Response to Comments on the Draft Environmental Impact Report Rich Haven Specific Plan

State Clearinghouse No. 2006-051081

Ontario, California

November 1, 2007

Rich-Haven Specific Plan TIA City of Ontario FIGURE 4
Existing Lane Configuration

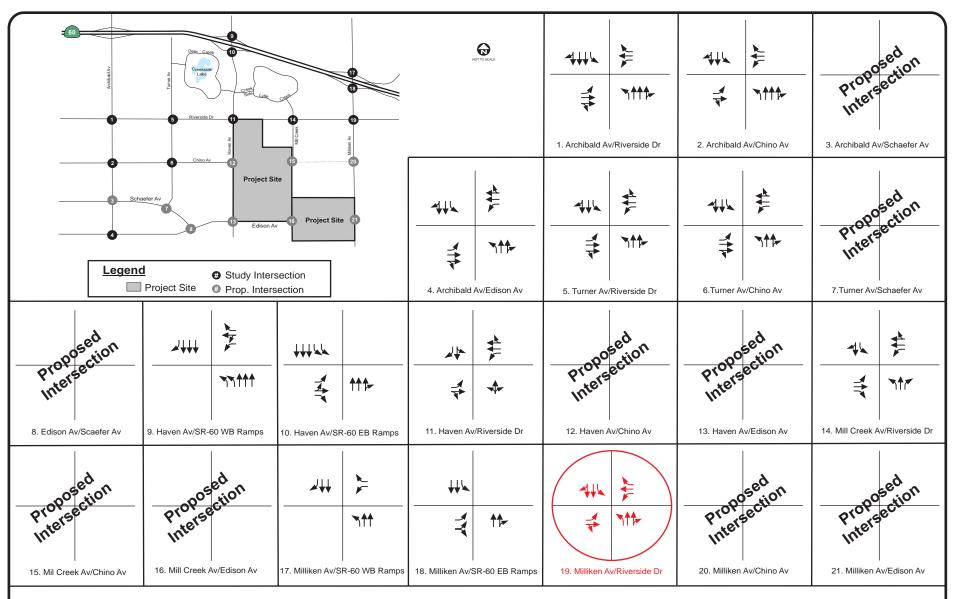
- A. Figure 4: The lane configurations at the intersection of Milliken Avenue/Riverside Drive have been upgraded subsequent to the analysis of this intersection. Please field-verify the lanes and revise the analysis of this intersection as appropriate.

Response to 4-9A. This comment states that the lane configurations at Milliken Avenue and Riverside Drive intersection have been upgraded and asks us to revise the analysis appropriately.

Thus, this intersection will perform better than originally estimated in the Draft EIR. Please refer to Attachment A at the end of this section for the detailed analysis worksheets and the revised figures and tables.

Rich-Haven Specific Plan TIA City of Ontario FIGURE 17

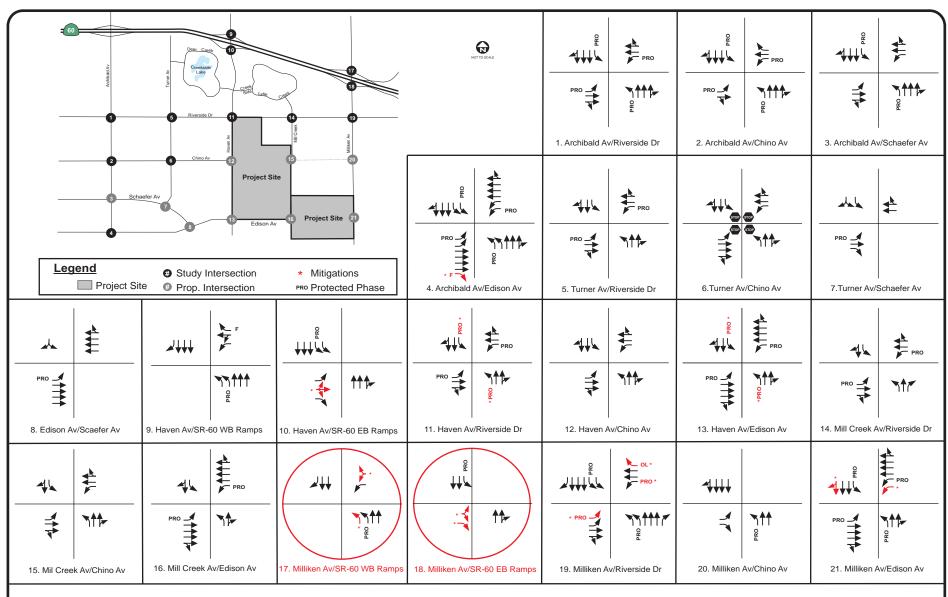
Pages 37 and 53 – 6.4 and 7.4 Recommended Mitigation Measures for 2015:
 Please address the following issues with the recommended mitigation measures.
 Provide conceptual roadway/intersection sketches showing dimensions.

- F. Figures 17and 19: Revise the mitigated lanes on this figure in accordance with Comment 13.
- G. Pages 41 and 55 6.5 and 7.5 Contribution of Project Trips to Future Traffic Volumes: Please point out which potential mitigation measures are infeasible and which are secondary. It is unclear if the secondary improvements have been analyzed. If not, please provide an analysis. Infeasible improvements do not constitute mitigation for the project and should not be included in the analysis.

Response to 4-5b. Milliken/SR-60 EB Ramps: In response to this comment, the mitigation measure T-1 has been amended and included in Section 4, Errata. The new mitigation measure proposes restriping the existing left turn lane into a shared left/right turn lane and re-striping the existing shared left/right turn lane into a right-turn only lane. The improvements can be accommodated within the existing right-of-way with no need for widening the off-ramp. The results are:

Intersection #18 Milliken Avenue/SR-60 EB Ramps

- restripe EB <u>left-turn only lane as a shared left-turn/right-turn lane</u>
- restripe EB shared left-turn/right-turn lane as a right-turn only lane
